6436 W. Hollywood Blvd  
DOT Case No. CEN 16-44677

Subject: **TRANSPORTATION IMPACT ASSESSMENT FOR THE PROPOSED  
MIXED-USE DEVELOPMENT PROJECT LOCATED AT 6436 WEST  
HOLLYWOOD BOULEVARD**

FIGURE 1

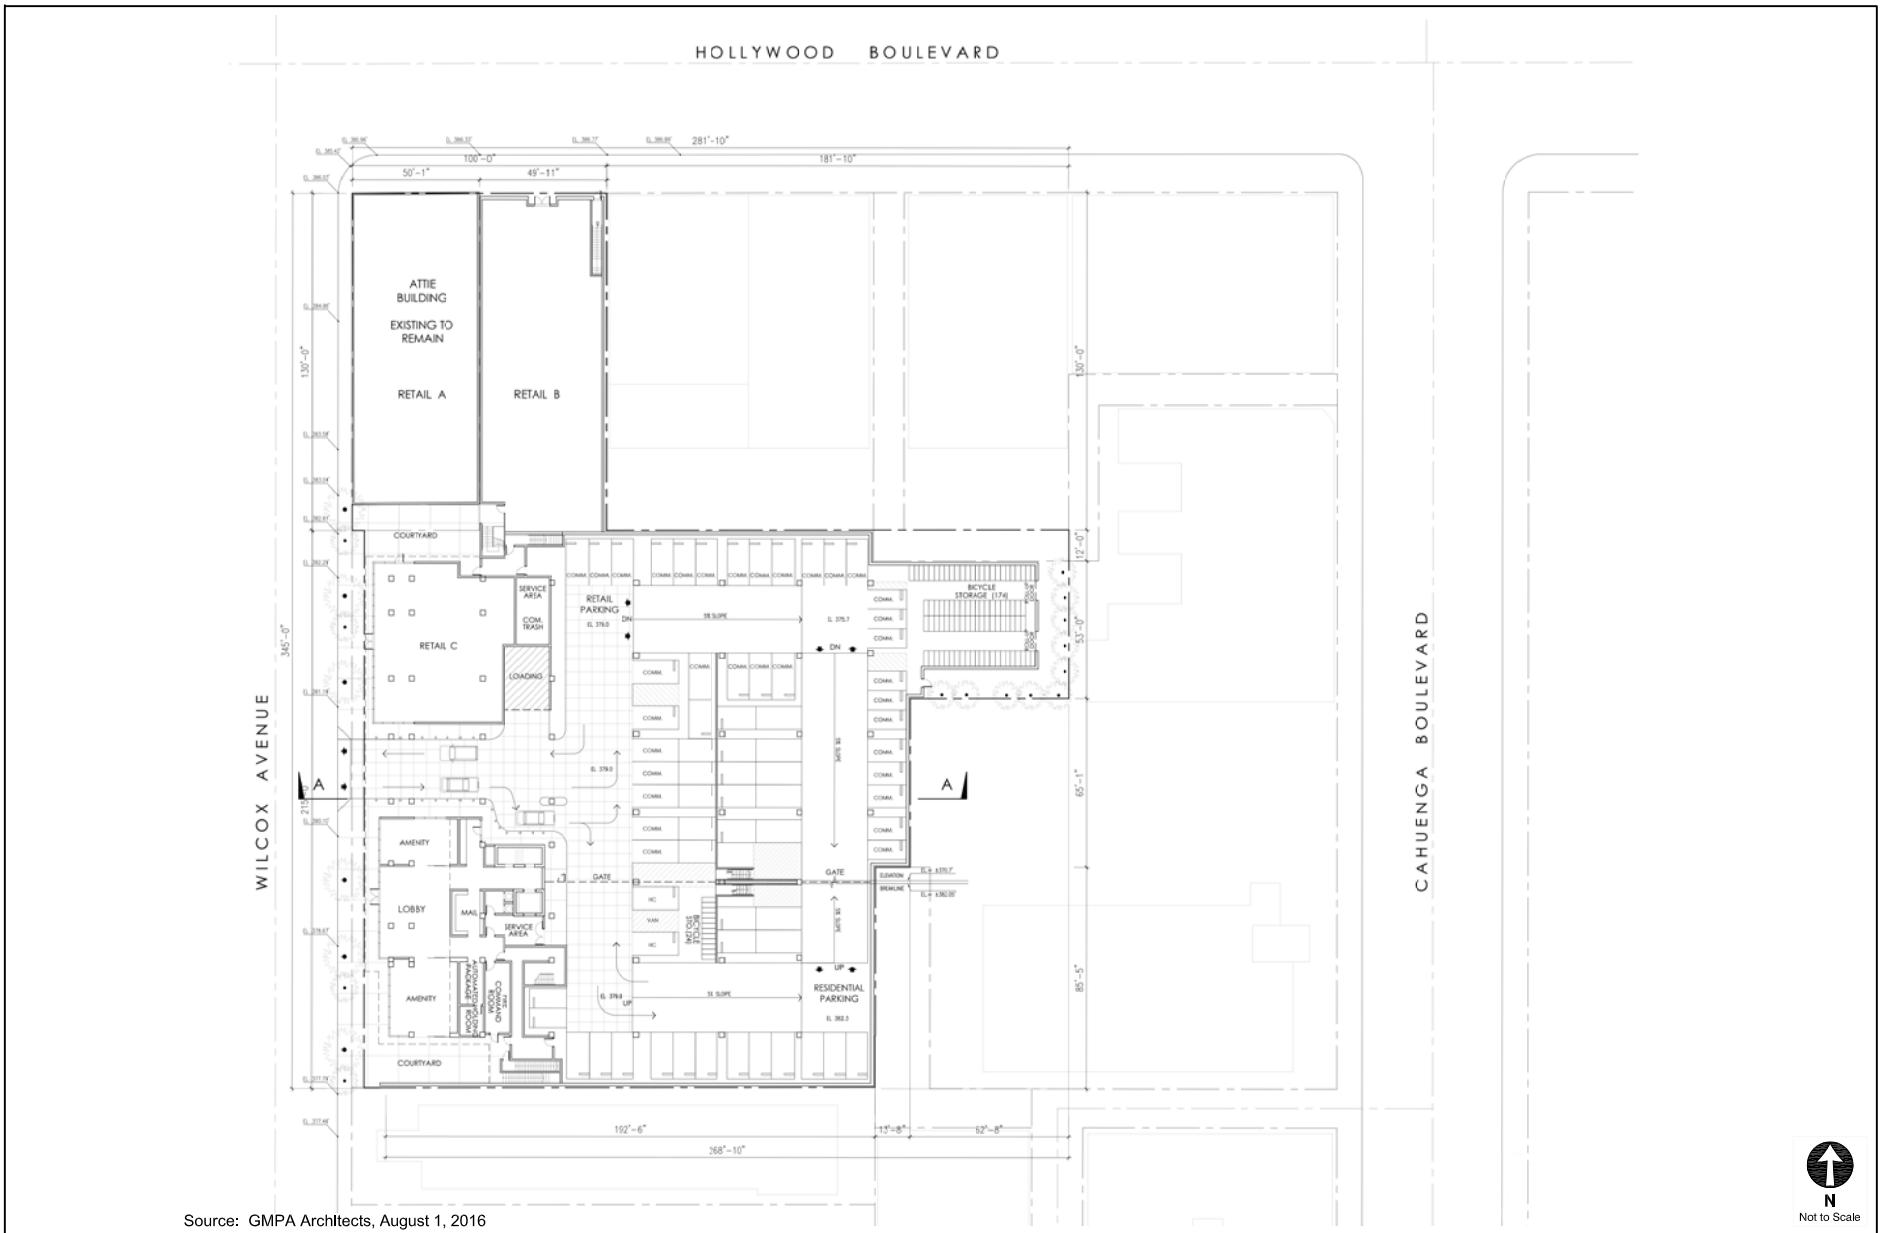
The proposed site plan illustrated in **Attachment 4** is acceptable to DOT; however, review of the study does not constitute approval of internal circulation schemes and driveway dimensions. Those require separate review and approval and should be coordinated with DOT's Citywide Planning Coordination Section (201 N. Figueroa Street, 5th Floor, Station 3, @ 213-482-7024). In order to minimize and prevent last minute building design changes, the applicant should contact DOT, prior to the commencement of building or parking layout design efforts, for driveway width and internal circulation requirements. Any changes to the project's site access, circulation scheme, or loading/unloading area after issuance of this report would require separate review and approval and should be coordinated as well.
